* SEE REVIEW COMMENTS FOR
MORE INFORMATION

APPROVED FOR CONSTRUCTION
CITY OF
WYLLIE
SUBJECT TO FIELD INSPECTION
AND CODE COMPLIANCE
DATE: 11/11/11
BY: [Signature]

LONE STAR GRANITE
114 Regency Drive
Wylie, Texas

FRONT ELEVATION

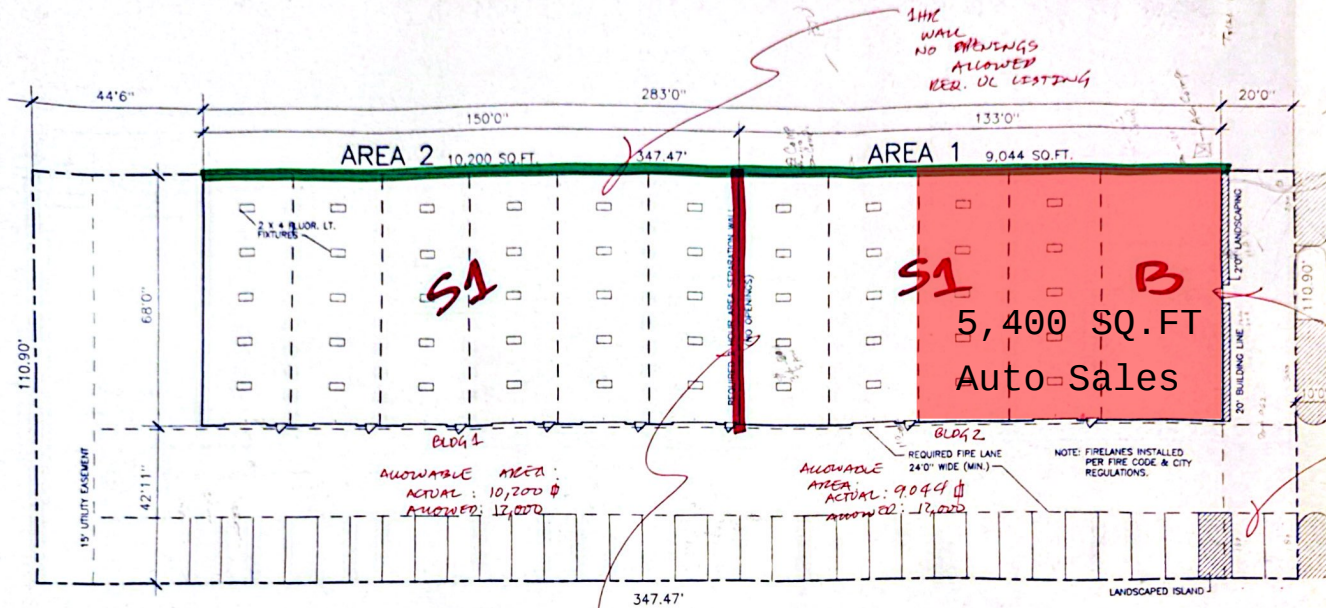
Change lights to
LED lights

SITE PLAN
SCALE: 1/16" = 1'0" LOT - 3, BLOCK - A.

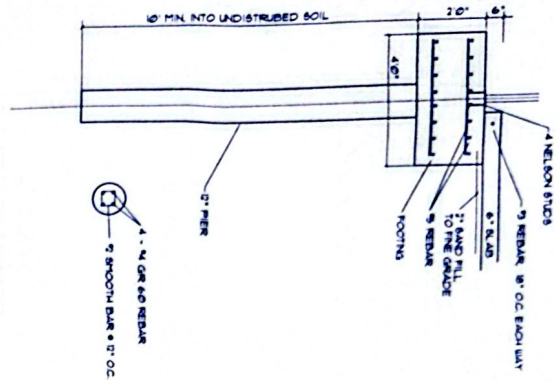
SEE ROOF AMENDMENTS
OF CITY OF
WYLLIE
SER. 2326.12.1

5% landscaping
required in
front of building
between Bldg. 1
front property line

H.C.
PARKING
REQ'D
W/EMP ACCESS
TO BLDG.

FIRST FLOOR PLAN

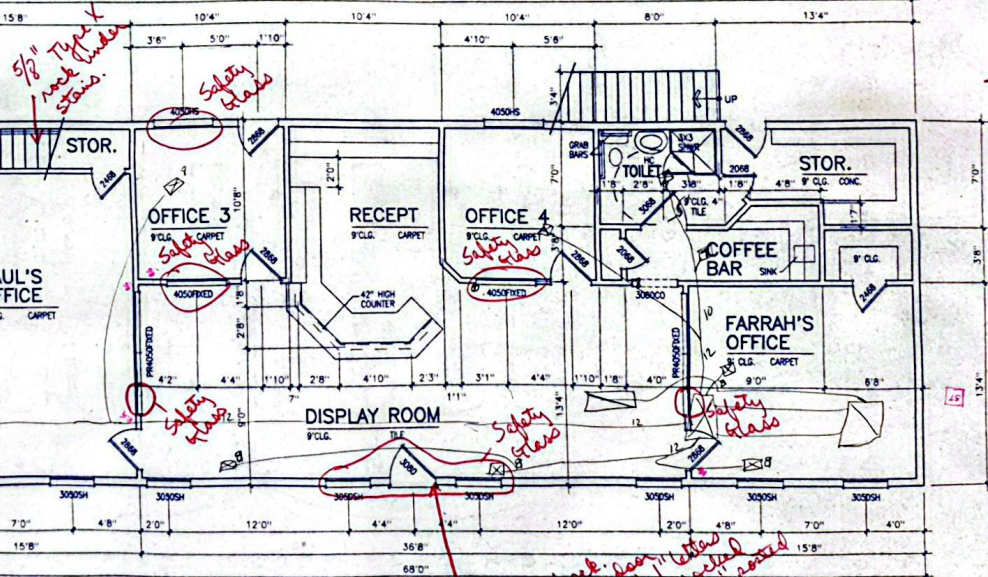
More than 4 employees requires 2 rest rooms.

Thumb latch lock. If double hung, this door will only must have a pin in latch. This door to remain unlatched during business hours, posted in only door.

- MAX. RISE - 7"
- MIN. RISE - 4"
- Highest + Smallest rise height cannot deviate more than 3/8"
- Handrail required Both sides. Top of rail located 34"-38" above nosing of treads.
- Open sides of stairs and landings must have 42" min height guardrail from finished floor.
- no openings in handrail or guardrail that a 4" sphere will pass through
- Handrail on 1 side must extend 12" beyond top and bottom nosing
- Handrails must end in newel posts or be returned (Not open on ends)

FIRST FLOOR ELECTRICAL PLAN

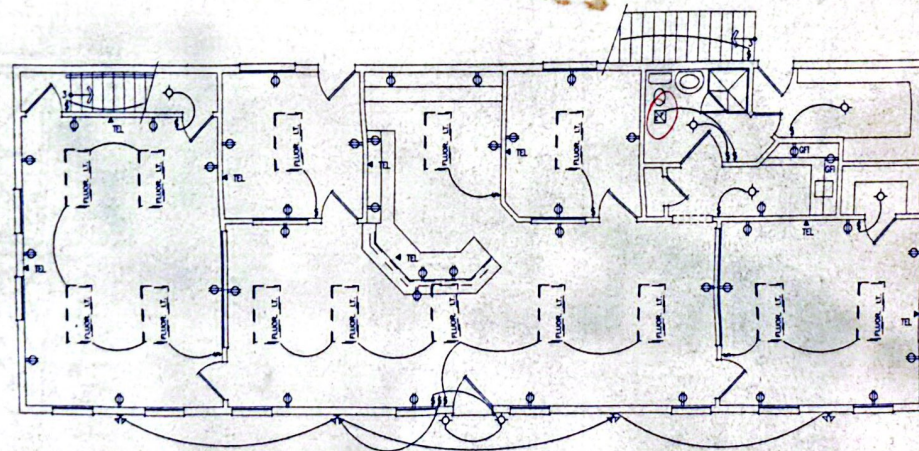
- MAX. RISE - 7"
- MIN. RISE - 4"
- Highest + Smallest riser height cannot deviate more than $\frac{3}{8}$ "
- Handrail required Both sides. Top of rail located 34"-38" above nosings of treads.
- Open sides of stairs and landings must have 42" min. height guardrail from finished floor.
- no openings in handrail or guardrail that a 4" sphere will pass through
- Handrail on 1 side must extend 12" beyond top and bottom riser
- Handrails must end in metal posts or be ~~secured~~ returned.
(Not open on ends)
